Big Eddy-Knight Transmission Project

Final Environmental Impact Statement

Volume 3: Comments and Responses

DOE/EIS-0421

10060-001

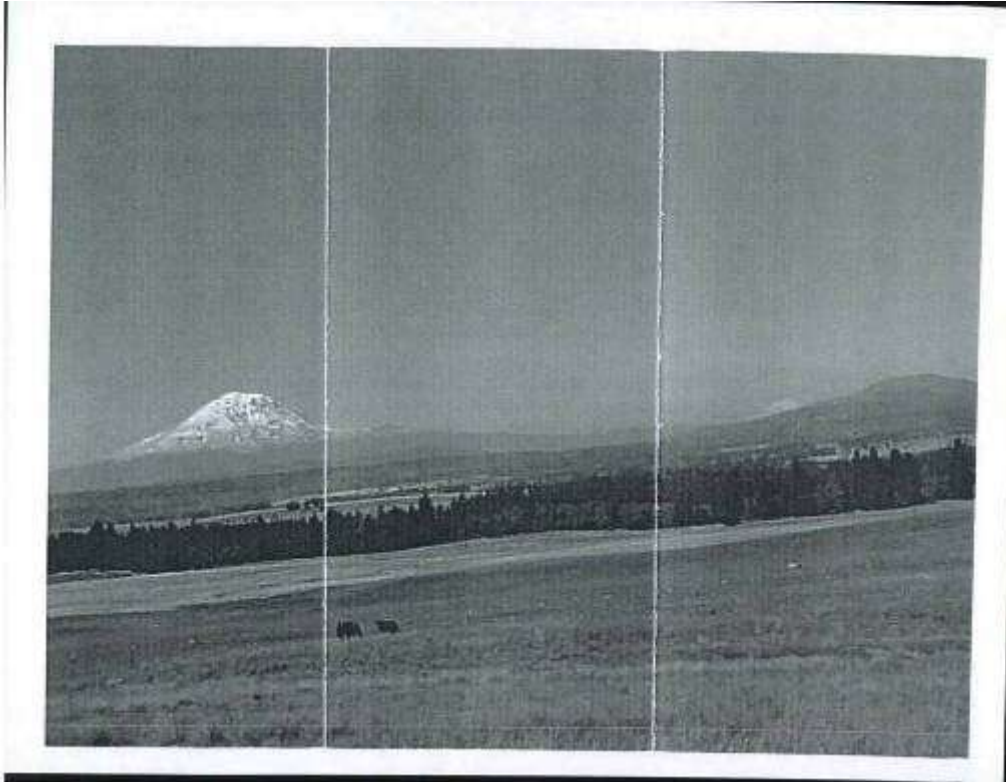
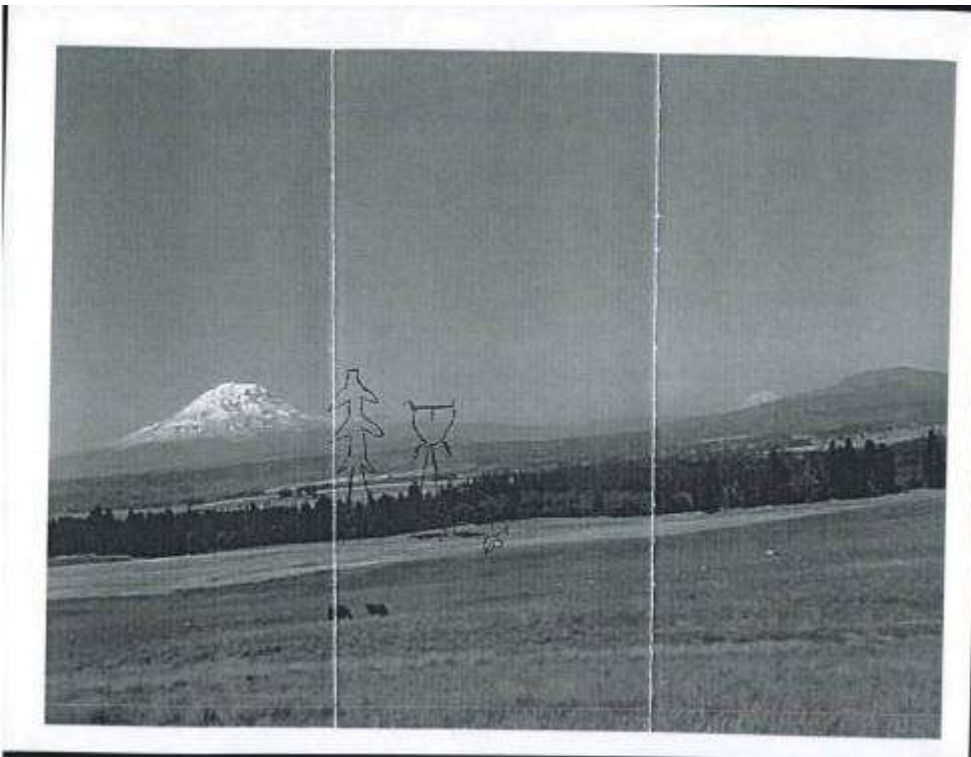
10011-004 I will forward supporting exhibits of my concerns on the Western Alternative visual impacts located between line mile w-18 and w-19. I simply have used maximum existing pole height and compare it with maximum single and double circuit pole heights. Figure 3-5 showing existing view versus simulated view in the EIS is not representative of the visual impacts on our development. Please make this e-mail a permanent part of the public record. Let me know if you have questions or need clarification on my statement or exhibits and please reply you have received this e-mail. Thanks.
Respectfully; Rob Kissler

10060-001 Thank you for the exhibits. They are part of the public record.
